Subject: Recall Campaign No. 05V-566

Subject: Recall Campaign for All 2005 and Certain 2006
Suzuki VZ800 and VL800 Motorcycles

4 - STROKE
VS/VX/VZ/VL BULLETIN NO. 33
DATE: 1/3/2006

SAFETY RECALL CAMPAIGN
ALL 2005 AND CERTAIN 2006 VL800/T/Z BOULEVARD C50/T
& VZ800 BOULEVARD M50 MOTORCYCLES
IGNITION SWITCH INSPECTION/REPLACEMENT

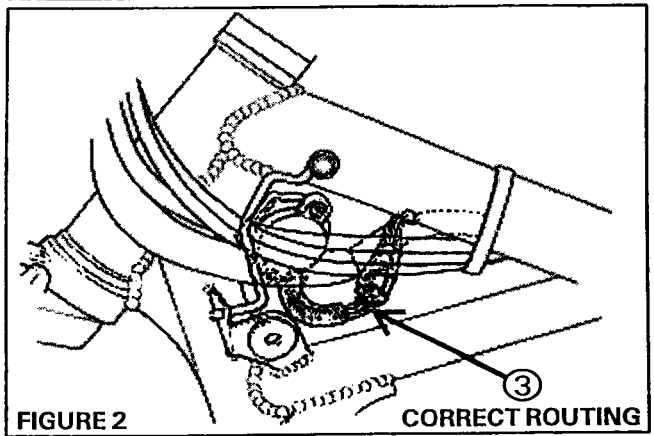
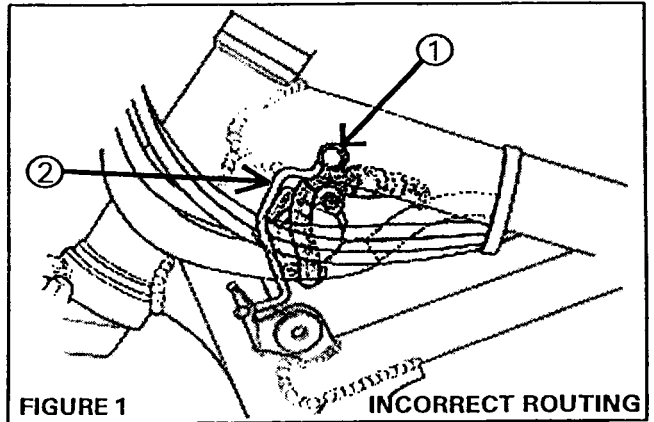
3. Remove ignition key and right side frame head cover. Remove left side frame head cover.
4. Inspect the ignition switch wiring harness (3) routing. If correct, re-install the frame head covers, fuel tank and front and rear seats. Proceed to Step 7.
5. If routing is incorrect, remove guide bolt (1) and guide (2) only. Inspect and re-route wires as shown in Figure 2.

If the protective covering over the ignition switch sub-harness is cut and the insulation of the lead wires is cut and/or abraded, replace the ignition switch and lock set. (Refer to VL800 Service Manual page 8-29 and VZ800 Service Manual page 9-35 for ignition switch replacement).

If the wire insulation is not cut and only the outer protective covering is damaged/cut, wrap the sub-harness with several wraps of electrical tape. In addition, if the clutch cable/throttle cable is damaged replace as necessary.

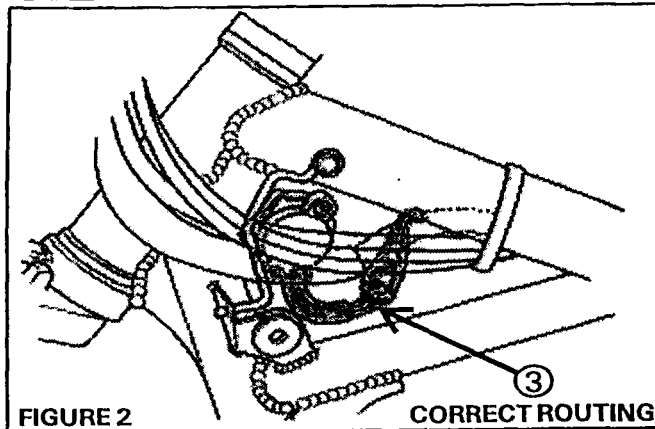
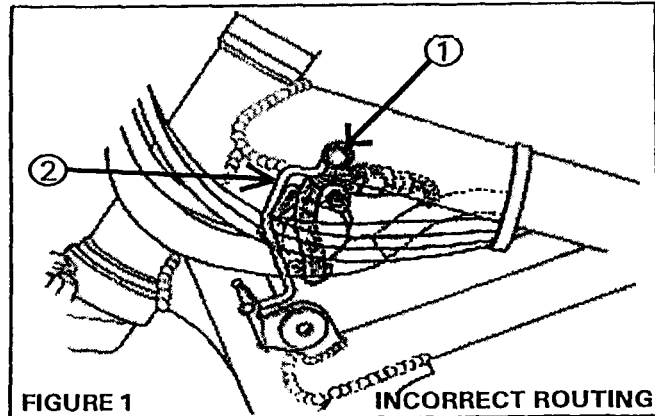
3. Remove ignition key and right side frame head cover. Remove left side frame head cover.
4. Inspect the ignition switch wiring harness (3) routing. If correct, re-install the frame head covers, fuel tank and front and rear seats. Proceed to Step 7.
5. If routing is incorrect, remove guide bolt (1) and guide (2) only. Inspect and re-route wires as shown in Figure 2.

If the protective covering over the ignition switch sub-harness is cut and the insulation of the lead wires is cut and/ or abraded, replace the ignition switch and lock set. (Refer to VL800 Service Manual page 8-29 and VZ800 Service Manual page 9-35 for ignition switch replacement).

If the wire insulation is not cut and only the outer protective covering is damaged/cut, wrap the sub-harness with several wraps of electrical tape. In addition, if the clutch cable/throttle cable is damaged replace as necessary.
